SERVICE BULLETIN

CHECKING OR REPLACEMENT OF THE EXHAUST BEND

ON ROTAX® ENGINE TYPE 914 (SERIES) SB-914-017

Bild / Fig. 1

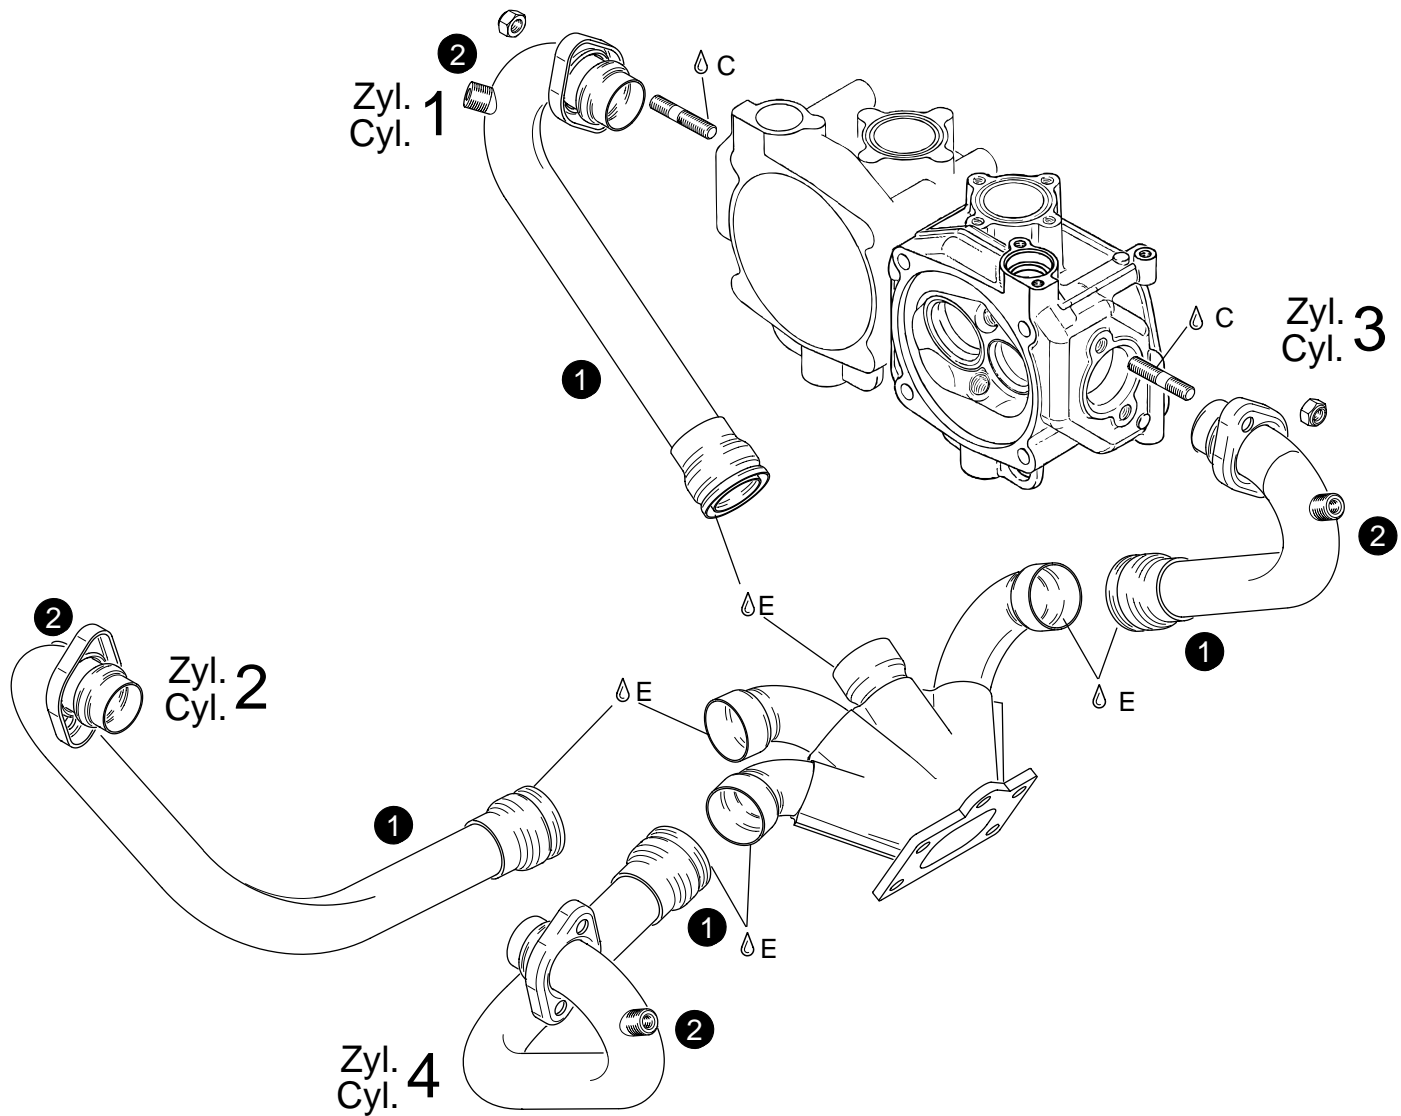
- Inspect the exhaust bends (1) in accordance with the relevant Maintenance Manual.

◆ **NOTE:** Scrutinize the exhaust bends for exterior traces of smoke, cracks and other faults especially about the EGT-terminals (2). See fig. 1.

- If cracks are detected replace the exhaust bend in accordance with the relevant Maintenance Manual.
- Reconnect negative terminal of aircraft battery.
